Re: Florida Power & Light Company  
Proposed Turkey Point Units 6 and 7  
Docket Nos. 52-040 and 52-041  
Response to NRC Environmental Request for Additional Information Letter  
1104071 (RAI 5588) Environmental Standard Review Plan  
Section 9.3.1 – Alternative Site Selection Process

Enclosure: Florida Power & Light Company, Turkey Point 6 & 7, New Nuclear Power  
Generation (Formerly Project Bluegrass) Augmented Site Selection Study  
Report, August 2011

**NRC RAI Number: EIS 9.3.1-2 (RAI 5588)**

**Figure 3-3 ROI Regional Screening Results – Southern Service Territory**

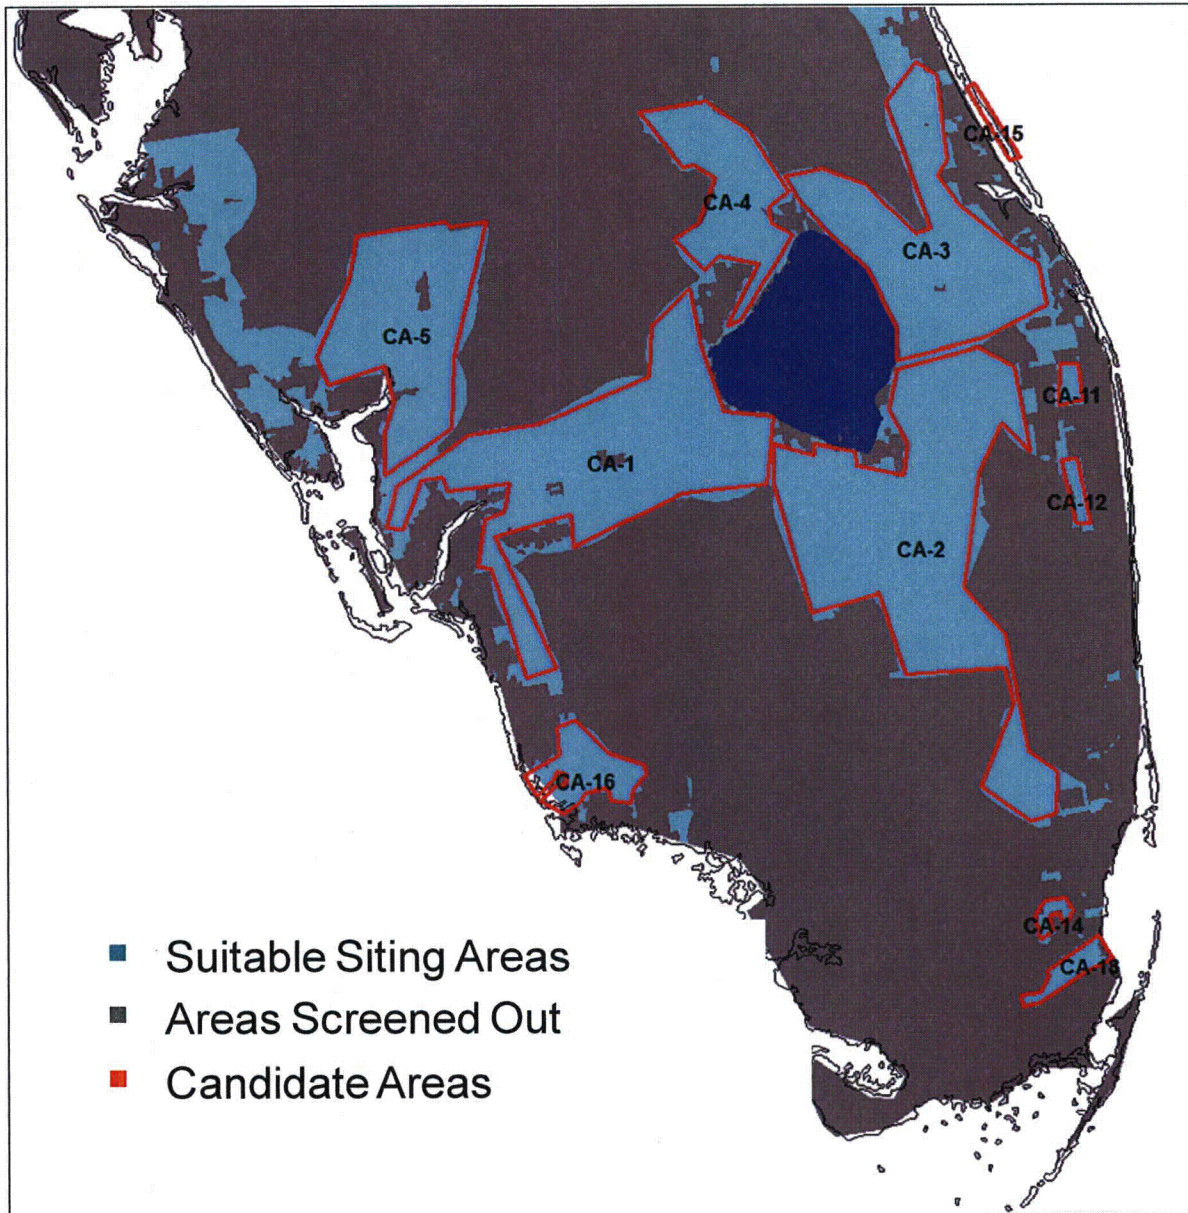
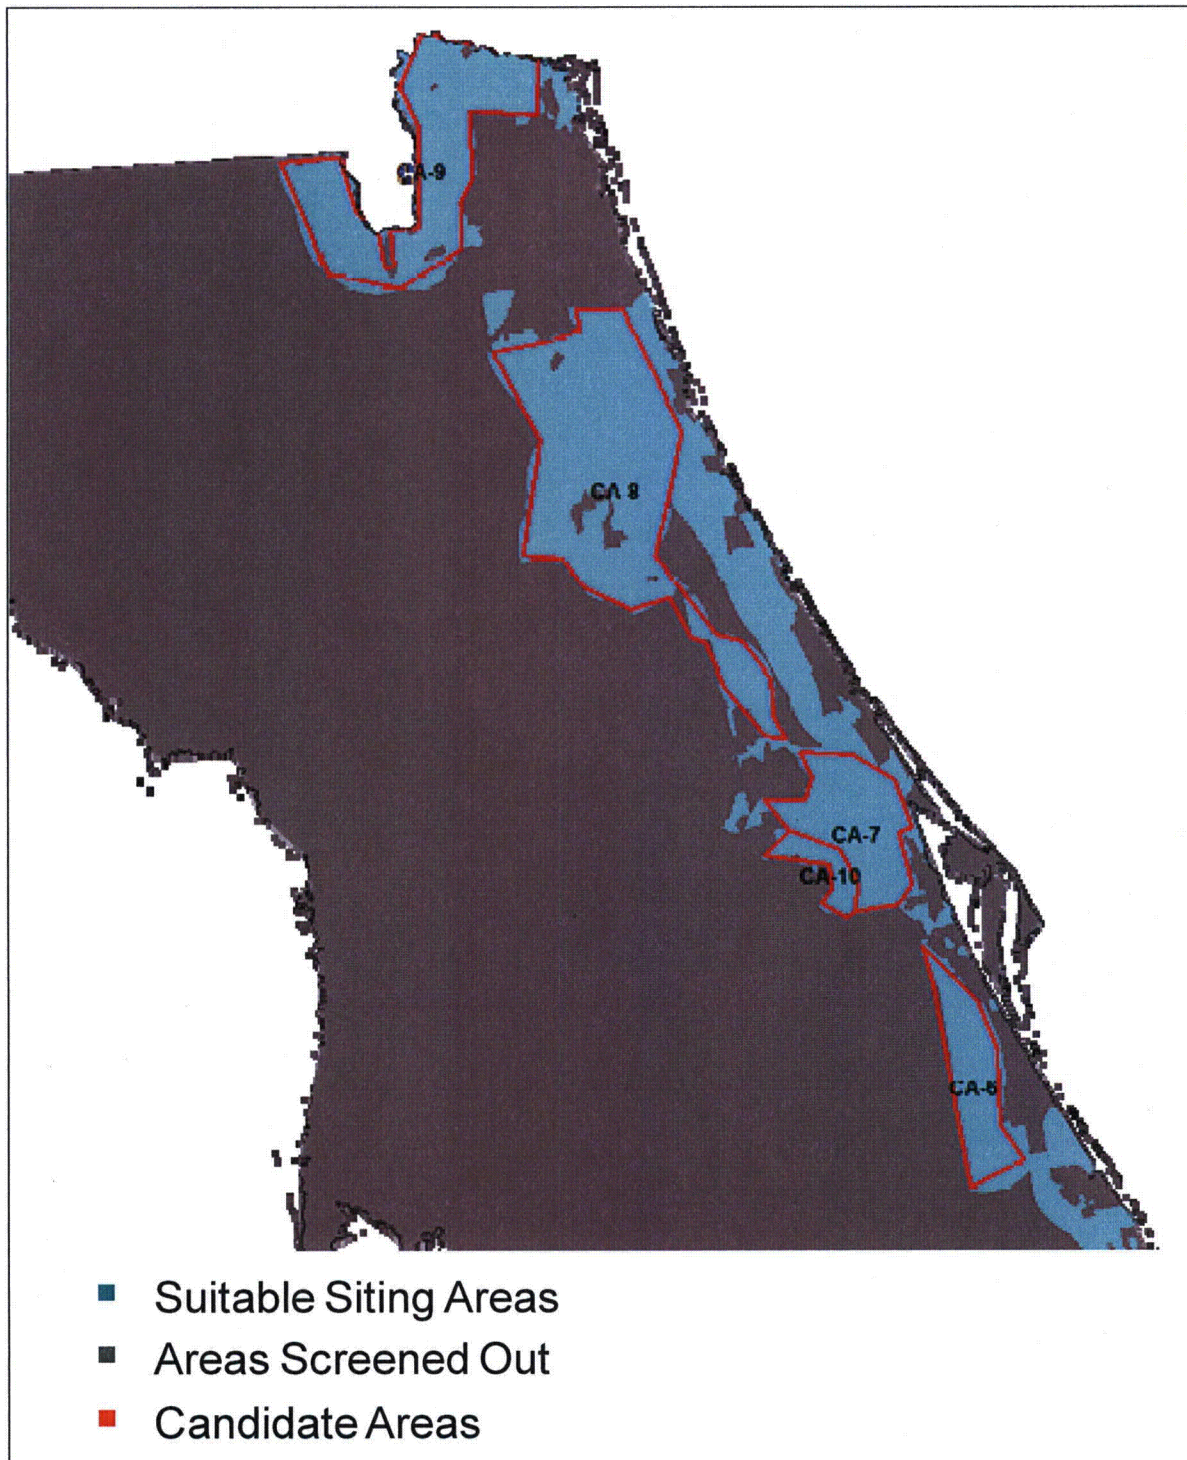
ER Section 9.3.2 indicates that FPL's consultant performed an independent evaluation of the region to ensure that no reasonable candidate areas were excluded (ER Rev 2, p 9.3-5). First, provide a hard copy of the related GIS information that was made available by FPL in the reading room. Second, provide the details of the alternative site screening processes summarized in ER Rev 2 Section 9.3.2 used by FPL's consultant and provide documentation that characterizes this screening and provides the results in the form of statistical tables and/or the "graphical representations" referred to in the ER. Finally, explain how exclusionary criteria were used in the screening process to identify candidate areas and compare these results to the areas/sites that were identified by FPL in the Siting Report (e.g., did the Siting Report consider sites in areas that fell outside the candidate areas identified by the consultant?).

Figures 3-3 and 3-4 depict the results of the regional screening process, identifying areas of higher suitability for siting a new nuclear power plant. The following 16 candidate areas were identified:
